**Re:** BusConnects Ballymun/Finglas to City Centre Core Bus Corridor Scheme  
Ballymun/Finglas to Dublin City Centre

ABP case ref: 314610

## **BUSCONNECTS BALLYMUN/FINGLAS CORE BUS CORRIDOR SCHEME**

Figure 1 NTA's 'Dublin-style' junction on Ballymun Road

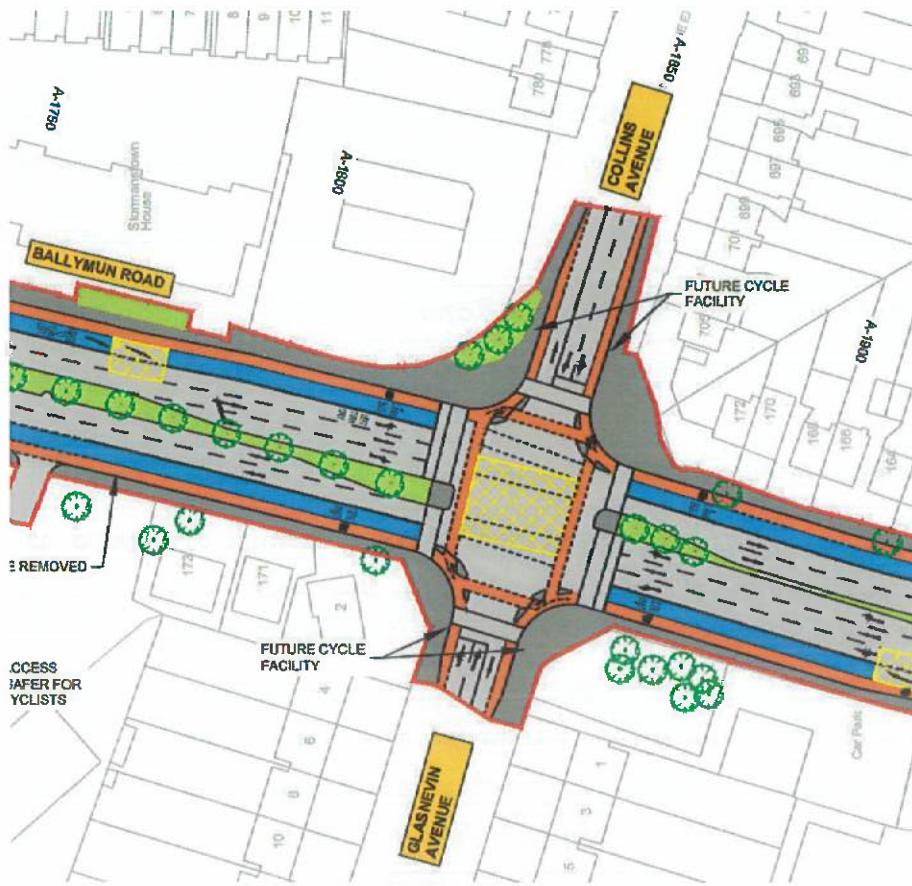
The primary junction design proposed by the National Transport Authority, the 'Dublin-style' junction (Figure 1), was designed by the NTA and does not follow international best practice in junction design. When compared to the proven Dutch junction, the NTA's design poses a greater risk of left-turning drivers colliding with cyclists. Additionally, the unusually large crossing distances for pedestrians' priorities driving over active forms of travel, contrary to best practices. The few existing examples of this NTA design in Dublin has been widely regarded as unsafe. We request that the NTA use Dutch-style junctions (Figure 2) throughout the project.

Figure 3 Junction between Phibsborough Road/Western Way/Constitution Hill with a five-stage pedestrian crossing

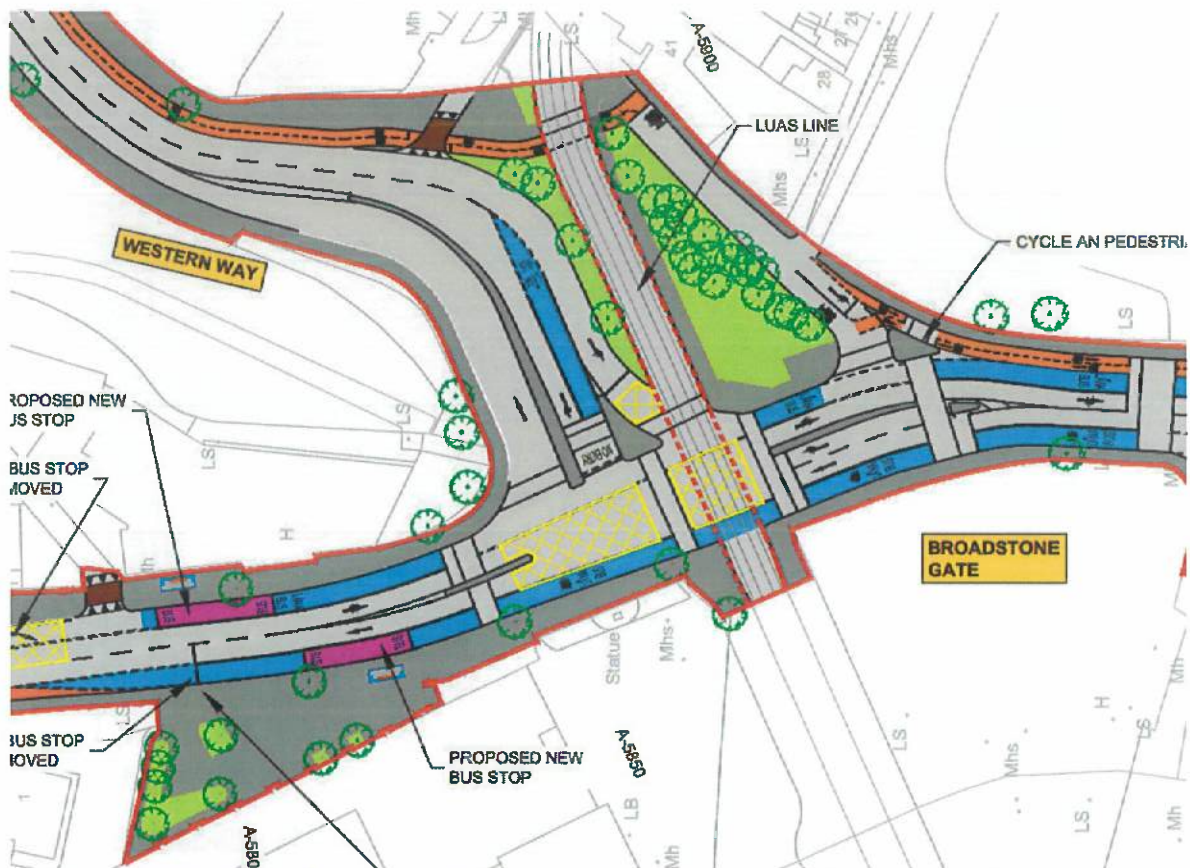
There are examples of two-stage pedestrian crossings proposed as part of this scheme. These crossings drastically increase the time required for pedestrians to navigate junctions and crossings. Section 4.4.3 Junction Design of the Design Manual for Urban Roads and Streets states that "designers should omit staggered crossings in favour of direct/single phase crossings" and Section 4.3.2 Pedestrian Crossings states that "designers should allow pedestrians to cross the street in a single, direct movement" and that "where staggered/staged crossings currently exist they should be removed as part of any major upgrade works".

- Western Way/Constitution Hill (five stage)
- Arran Quay/Church Street (sheet 18)

Figure 4 Bus stops with inadequate bus stop islands for cycling on Ballymun Road near Hampstead Avenue

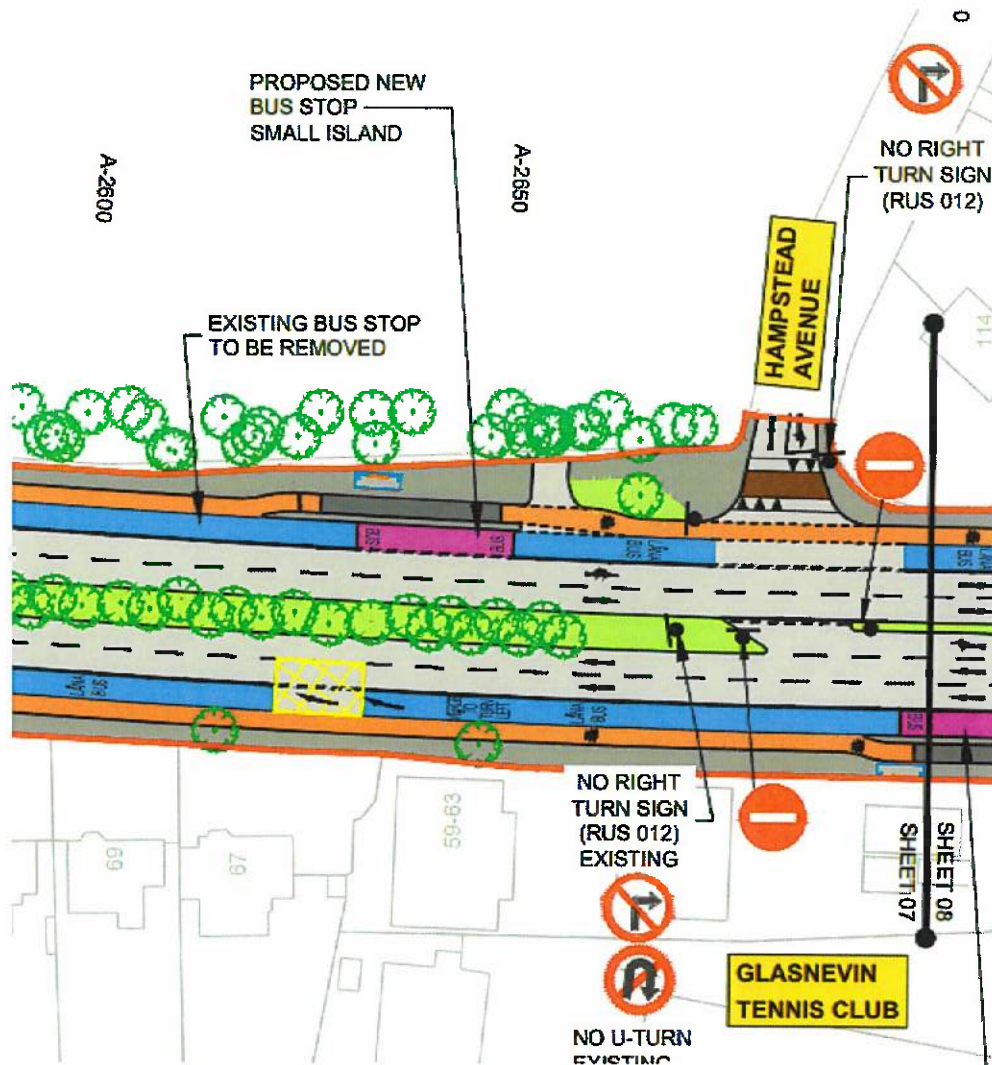
A major concern throughout the Proposed Scheme is the width of the bus stop islands that are proposed. Bus stop islands are crucial for the safety of cyclists and for encouraging all ages and abilities to use cycling infrastructure by removing conflicts between buses and bicycles. However, narrow islands place cyclists in conflict with boarding and alighting bus passengers.

- Northbound on Ballymun Road near junction with St. Pappin Road
- Both directions on Ballymun Road near Hampstead Avenue
- Southbound on Botanic Road near Fairfield Road.
- Northbound on Botanic Road near Marguerite Road
- Northbound on Finglas Road near Dalcassian Downs
- Southbound on Prospect Road near Prospect Road
- Northbound on Constitution Hill opposite Kings Inns
- Southbound on Church Street near Coleraine Street
- All along Glasnevin Hill and Botanic Road
- Northbound on Finglas Road near Church Street
- Northbound on Finglas Road near Wellmount Road
- Northbound on Finglas Road near Ballyboggan Road
- Southbound on Finglas Road near Claremont Lawns
- Southbound on Finglas Road near Prospect Way

Figure 5 GDA Cycle Network Plan

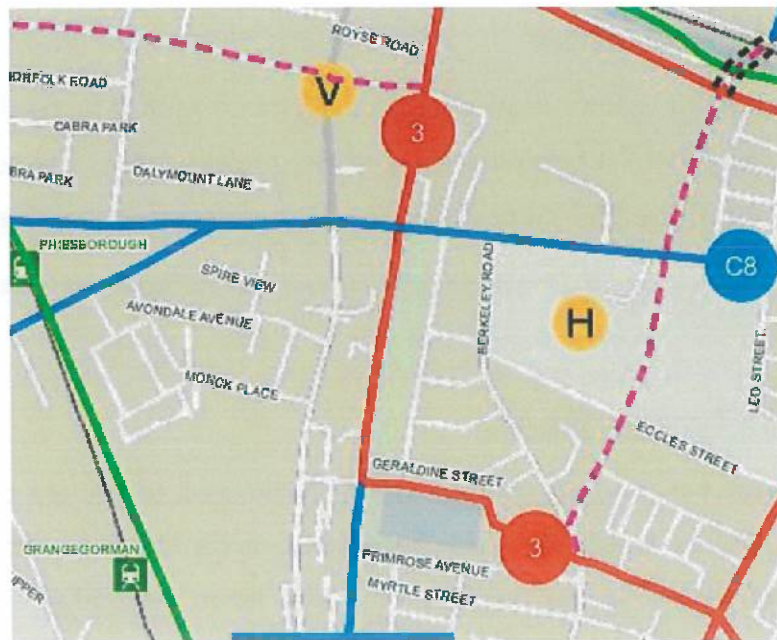
Ideally the segregated cycle lane along the royal canal bank should be created AND cycle lanes should be maintained through Phibsborough. The plan to remove cycle lanes on Phibsborough Road doesn't align with the GDA Cycle Network Plan. Phibsborough Road is a primary cycle route. Under MetroLink and DART+, the busiest interchange in Ireland is planned in Phibsborough and yet this area will have no cycling infrastructure.

1. There is shared space for pedestrians and cyclists on the North Circular Road underpass – this is a terrible idea and will inevitably lead to conflicts.
2. It is not accessible. It shouldn't just be a cycle track for people passing north south through Phibsborough, it needs to also be a cycle route that it accessible to people living on the east and west of it, and there appears to be no efforts to connect the cycle route with people living on/off Connaught St, around Shandon, on/off Whitworth Road, around Avondale/Great Western Square, or simply on Phibsborough Road. There should be cycle lanes on Whitworth Road, but as can be seen on Sheet 13 there appears to be no plans to install them.

Figure 6 Ballymun Main Street

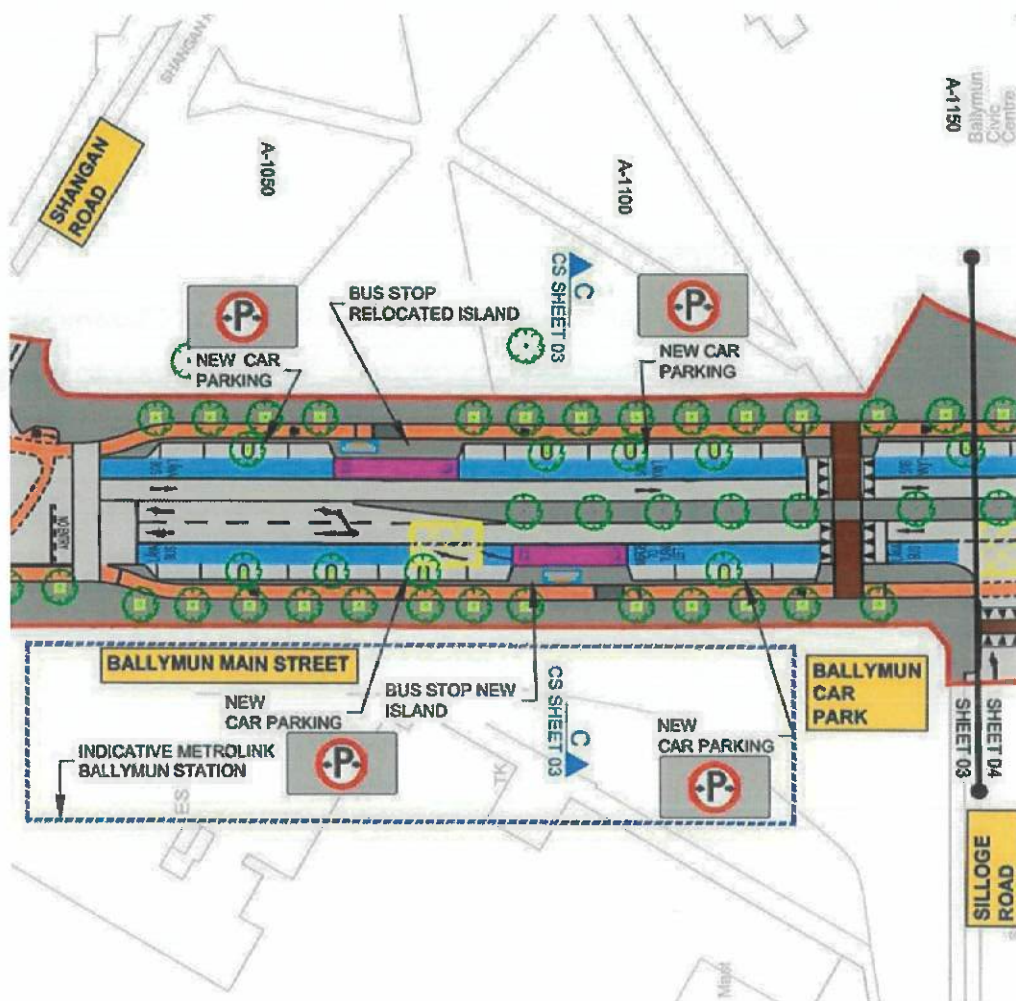
We are pleased to see some progress made on parts of Ballymun Main Street with the removal of a general traffic lane in each direction. We ask however that this space not be used for on-street parking which currently does not exist. We would like to see the proposed new parking replaced with planting thereby creating more space for pedestrians on the footpath. We would also like to see the removal of the median which is inappropriate for this urban street.
